**R E M A R K S**

**THE DRAWINGS**

FIGS. 1-46 have been replaced by the attached replacement sheets which more clearly show the features of the present invention, as required by the Examiner.

Fig. 5

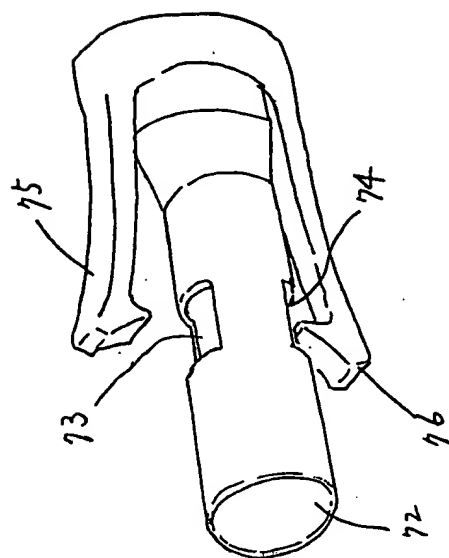
The replacement sheets for FIGS. 1, 5, 7-13, 15A and 15B, 16A and 16B, 17, 18, 22-25, 28-30, 34-36, 41, 45 and 46, incorporate the amendments described hereinabove, which correct various minor informalities of which the undersigned has become aware. Annotated sheets corresponding to the amended drawings are submitted herewith to show the changes made thereto.

Fig. 18

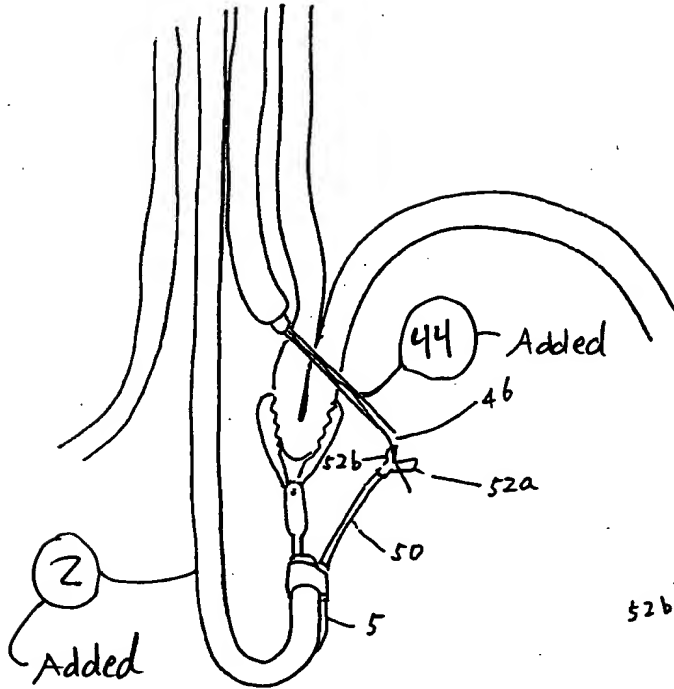
Moved to  
separate  
sheet
